PCI Design Handbook **ERRATA**

PCI Design Handbook

Precast and Prestressed Concrete, Seventh Edition

In 2010, the Precast/Prestressed Concrete Institute published the seventh edition of the *PCI Design Handbook*: *Precast and Prestressed Concrete* (MNL–120–10). Although careful efforts were made to provide an accurate document, some errors have been discovered. We suggest that you mark your seventh edition to reflect these errata so that the handbook is as accurate as possible.

Fig. 4.5.1 (Revised in accordance with 2011 Errata) Unsymmetrical shear walls.

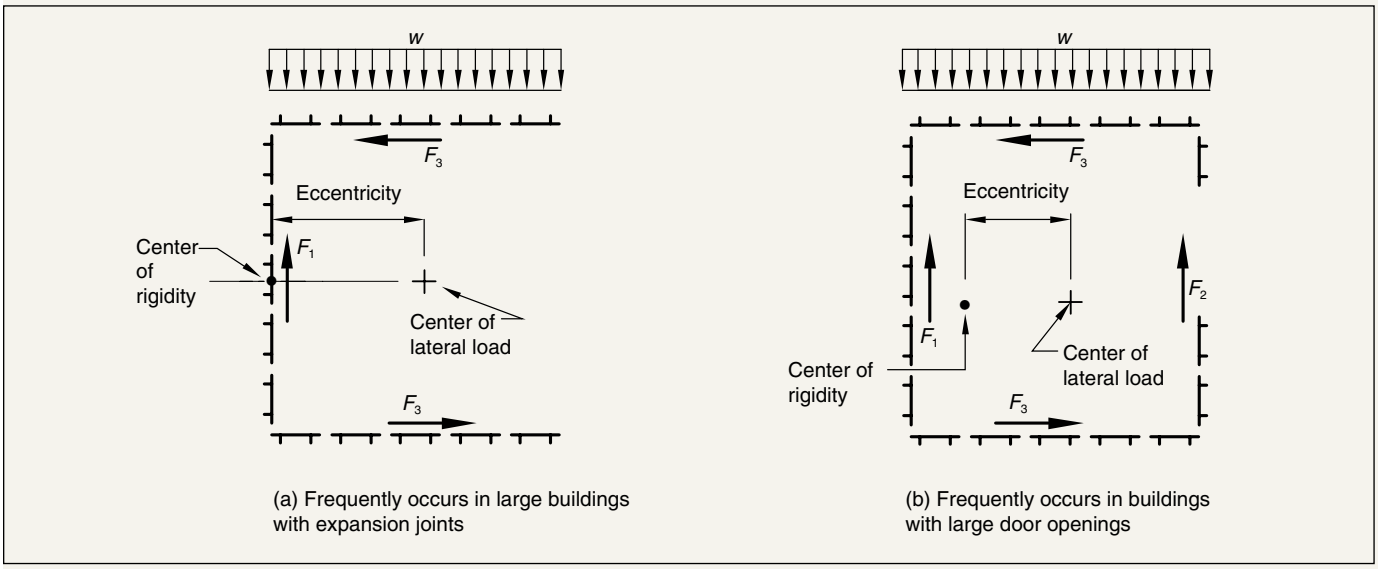
Page 4-22, Fig. 4.5.1: The locations of the center of rigidity and center of lateral load in the left diagram are not correct. The location of the center of lateral load in the right diagram is not correct. Replace with Fig. 4.5.1 as revised.

Fig. 4.8.4 (Revised in accordance with 2011 Errata) Collector force demand diagram for shear walls in a parking garage.

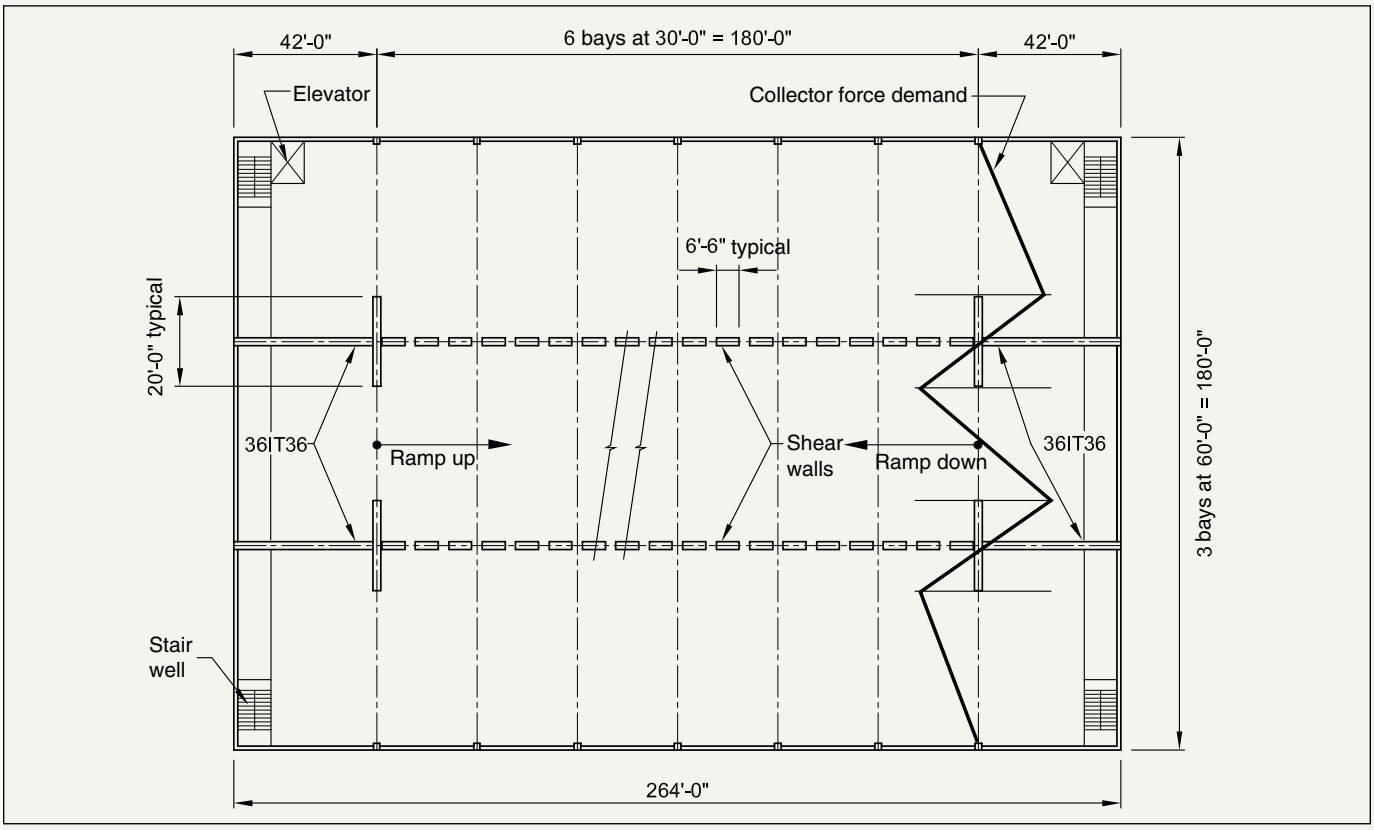
Page 4-58, Fig. 4.8.4: The peak line for the collector force demand should line up with the upper end of the lower shear wall. Replace with Fig. 4.8.4 as revised.

Fig. 5.9.7 (Revised in accordance with 2011 Errata) Typical pile interaction curve.

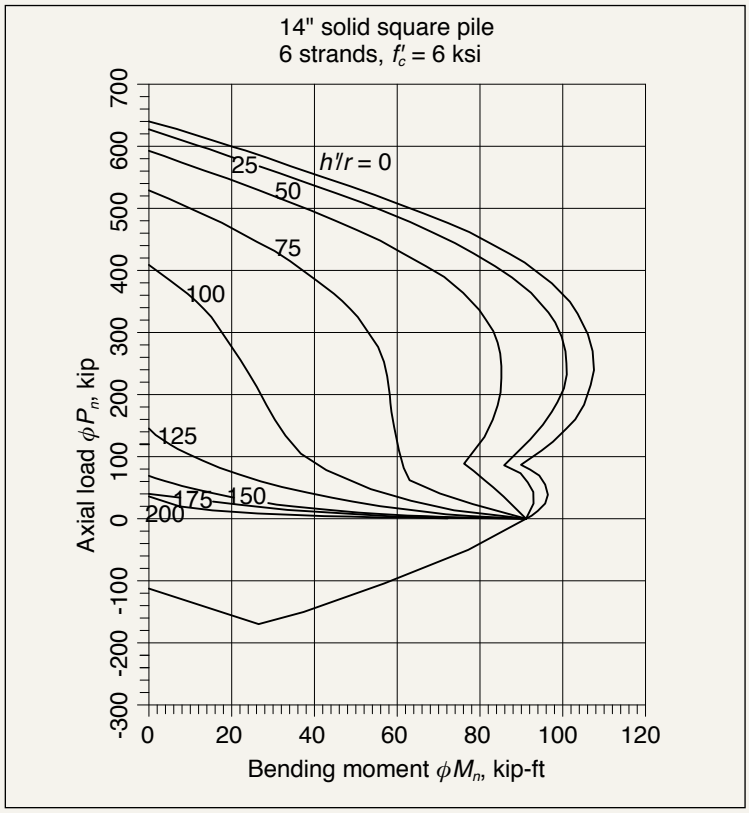
Page 5-116, Fig. 5.9.7: Curve for h′/r = 0 should not have the slight uptick at zero bending moment. Replace with Fig. 5.9.7 as revised.

EXAMPLE 5.2.3.2 (Revised in accordance with 2011 Errata)

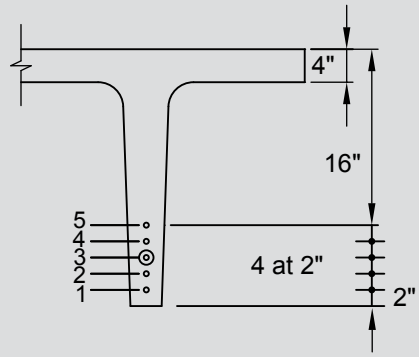
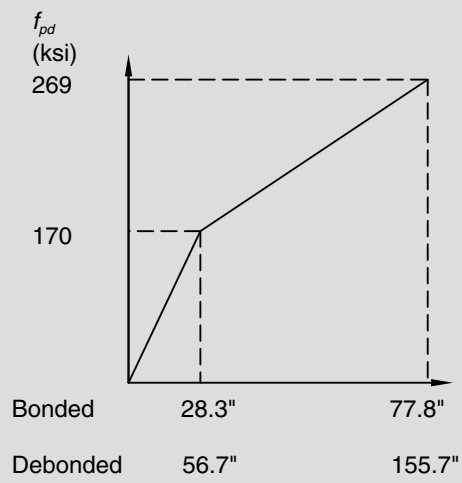
Page 5-38, Example 5.2.3.2: The example does not coincide with the text in that it does not properly account for the load in the partially developed strand. Replace with Example 5.2.3.2 as revised.

Note: Due to the presence of underdeveloped strand adjacent to fully developed strand the assumption of strain compatibility is not valid at this section. At capacity the underdeveloped strand will slip while maintaining partial development as necessary for the fully developed strands to adequately strain in order to yield.

Design Aid 6.15.3 (Revised in accordance with 2011 Errata)
Minimum Length of Weld to Develop Full Strength of Bar. Weld Parallel to Bar Length[a,b,c]

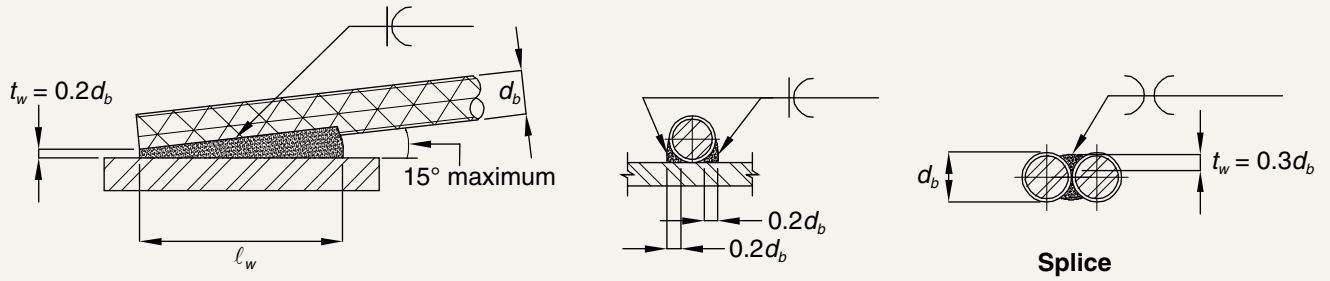
Page 6-102, Design Aid 6.15.3: Replace with Design Aid 6.15.3 as revised.

Design Aid 6.15.4 (Revised in accordance with 2011 Errata)
Size of Fillet Weld Required to Develop Full Strength of Bar. Butt Weld.

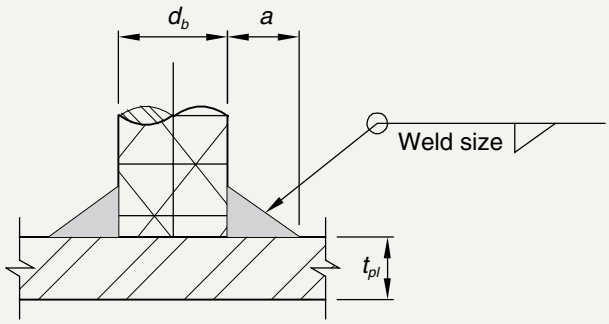
Page 6-103, Design Aid 6.15.4: Replace with Design Aid 6.15.4 as revised.

Design Aid 6.15.5 (Revised in accordance with 2011 Errata)
Size of Fillet Weld Required to Develop Full Strength of Bar. Weld Through Hole.

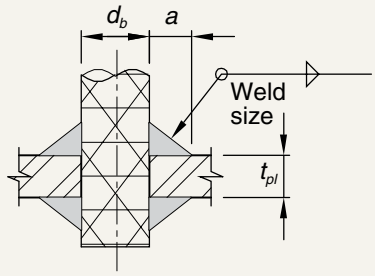
Page 6-104, Design Aid 6.15.5: Replace with Design Aid 6.15.5 as revised.
